IN THE DRAWINGS:

REMARKS

FIG. 2

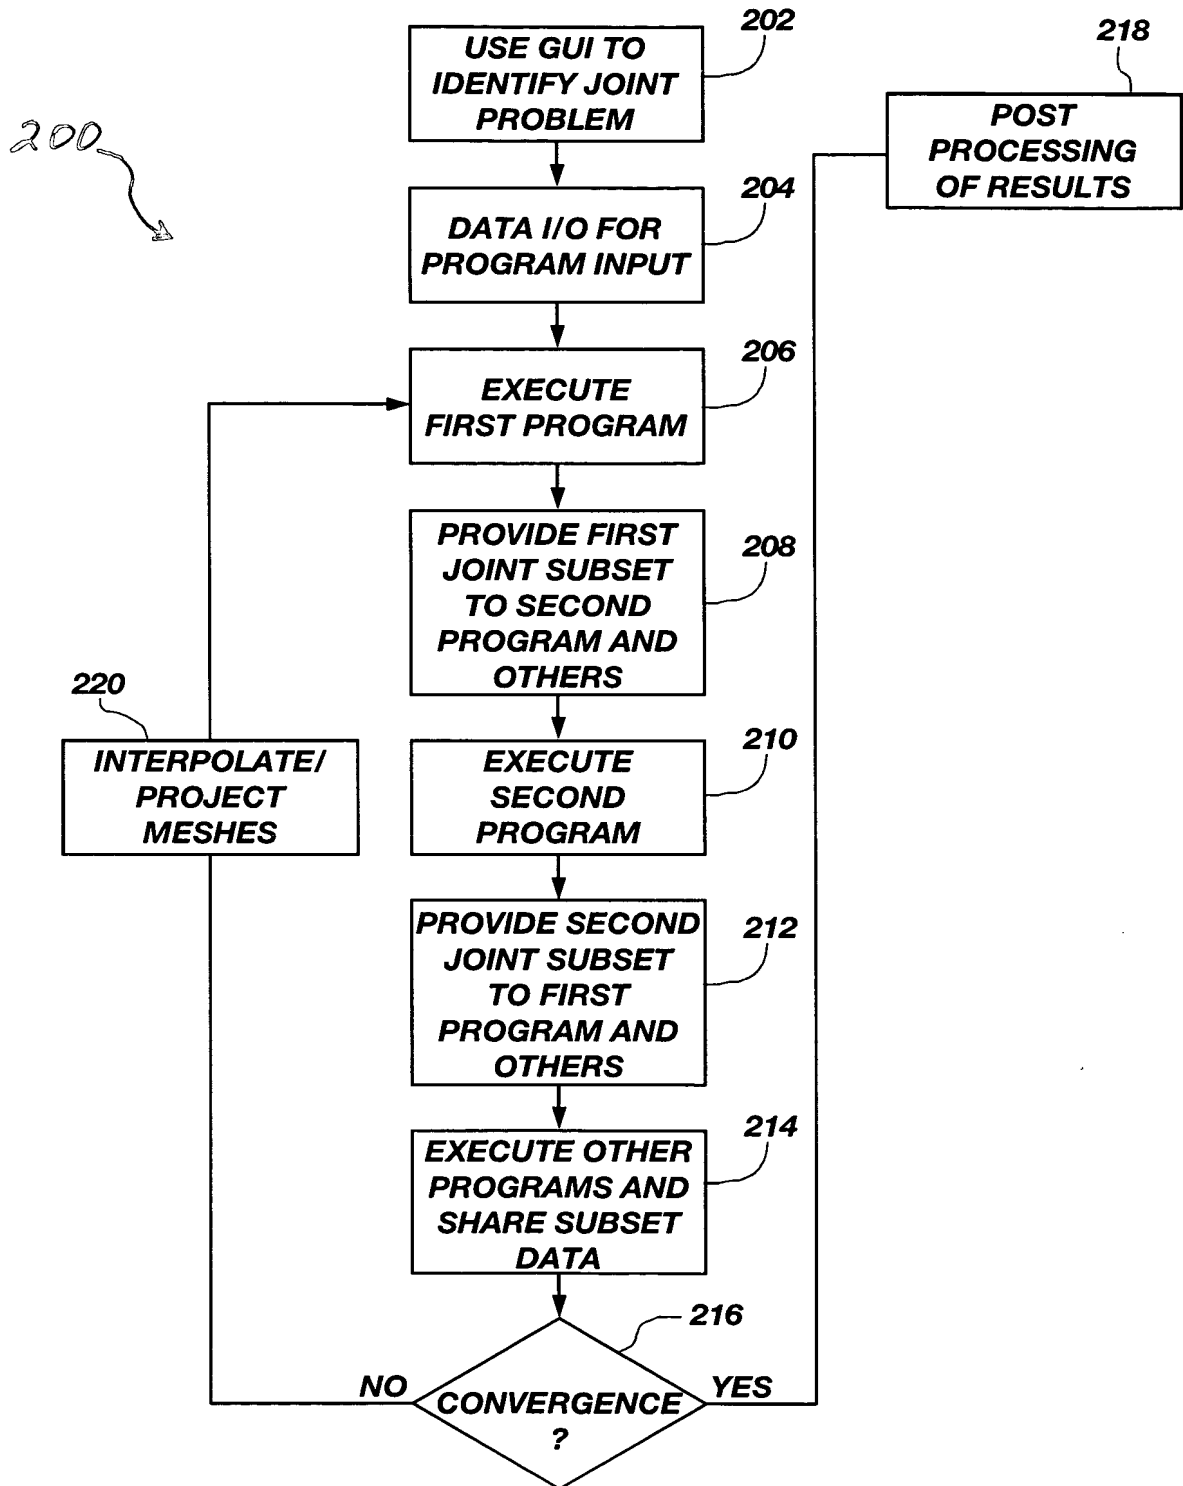
Specifically, FIG. 2 has been revised to add the reference numeral --200-- with appropriate lead line arrow; and FIG. 3 has been revised to change the wording in the fifth line below the box labeled by reference numeral --412-- from "*VESTOR PLOTS*" to --*VECTOR PLOTS*--. No new matter has been added.
